**COMMUNITY DEVELOPMENT
DEPARTMENT REPORT**

HEARING DATE: 3/17/2025
TO: Mayor & City Council
FROM: Sonya Allen, Associate Planner
208-884-5533
sallen@meridiacity.org
APPLICANT: Brighton Corporation
SUBJECT: H-2025-0051; A-2025-0152
Driftwood Townhomes Subdivision
LOCATION: Generally located north of W. Ustick Rd. (Parcel #R1931270100), on the west side of N. Venable Ave., in the SE 1/4 of Section 36, T.4N., R.1W.

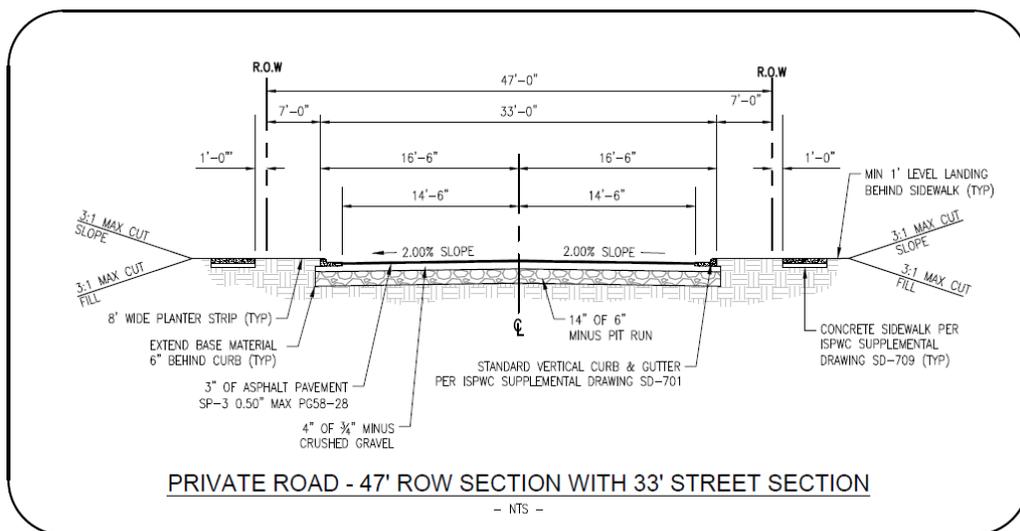
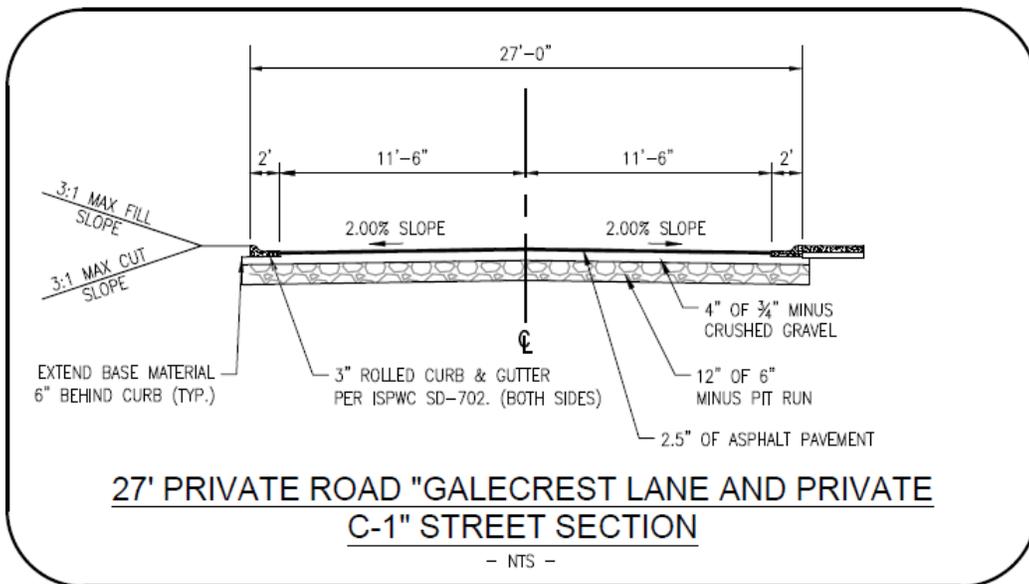
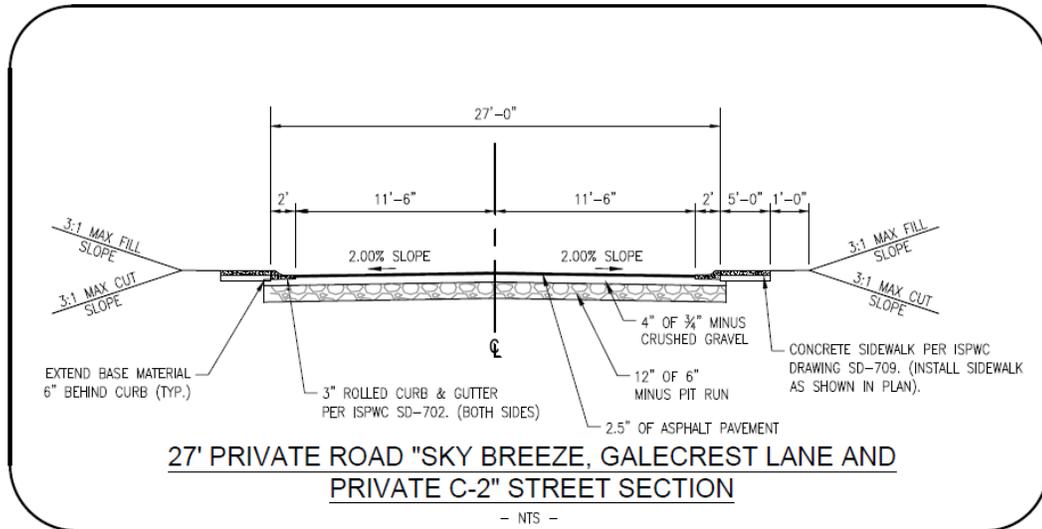
A 5' wide detached sidewalk is required within the street buffer along N. Venable Ave., a collector street, and a 5' wide attached sidewalk or 4' wide detached sidewalk is required along the proposed private streets. A 5' wide detached sidewalk exists along both sides of the proposed private street adjacent to the southern boundary of the development.

The Applicant requests Director approval of a modification to the requirement along private streets on Lot 1, Block 1 to allow a 4' instead of 5' wide attached sidewalk. Such modifications are allowed if the Applicant can demonstrate that an alternative similar pedestrian path exists. The Director finds the proposed sidewalk provides a similar pedestrian path as required for a modification; therefore, the modification is approved.

Staff recommends an attached 4' wide sidewalk is provided along the west side of Alley A for safe pedestrian access within the development in accord with UDC 11-3F-4A.2.

I. Pedestrian Plan

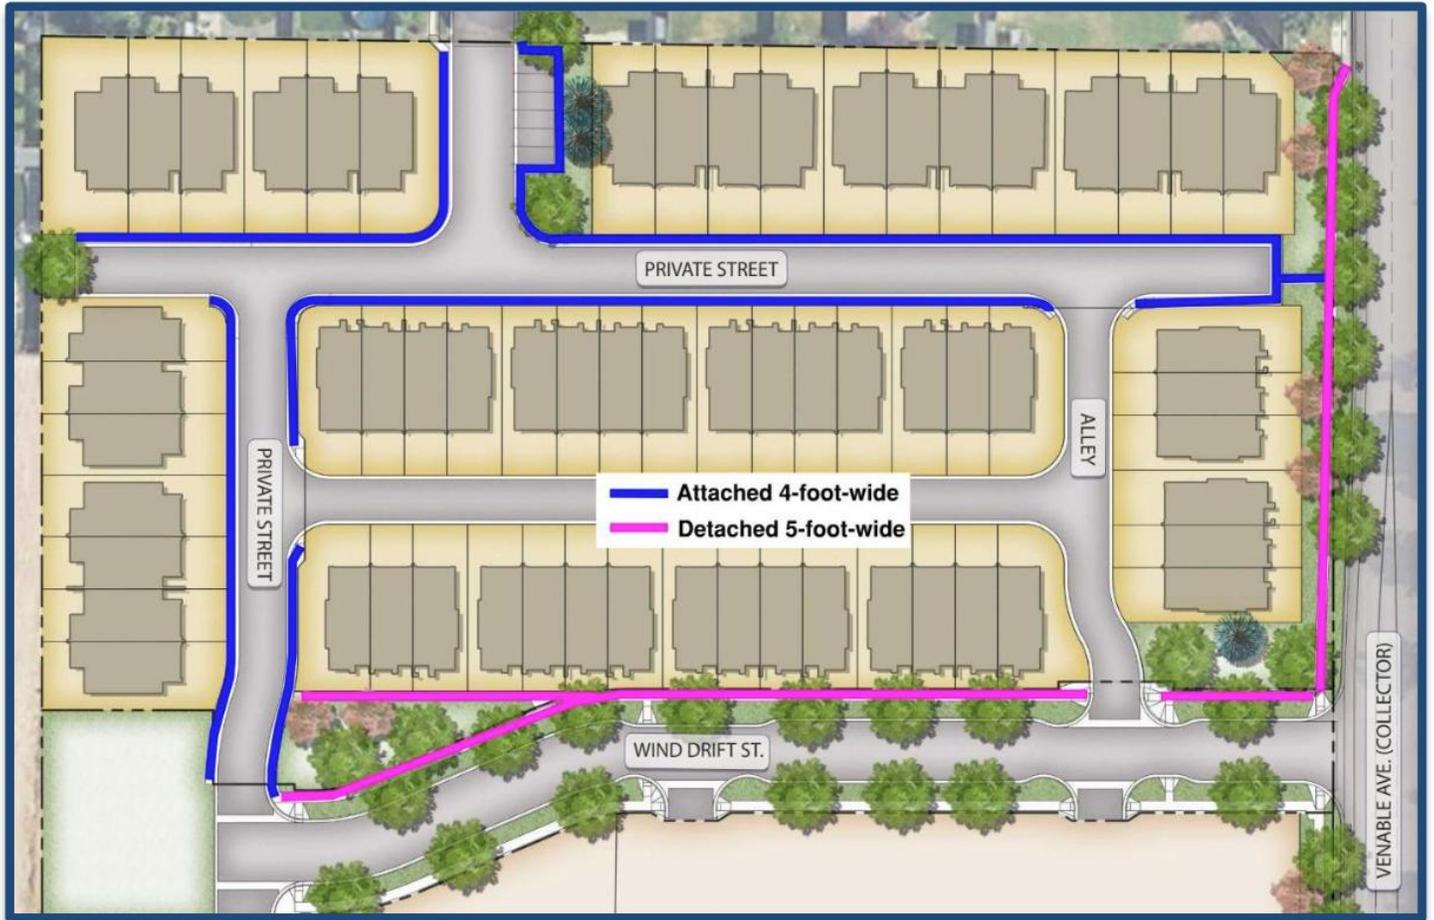
A pedestrian plan was submitted that shows internal pedestrian pathways and sidewalks along streets, included below in Section VII.I.

- iv. Depict an attached 4' wide sidewalk along the west side of Alley A for safe pedestrian access within the development in accord with UDC 11-3F-4A.2.
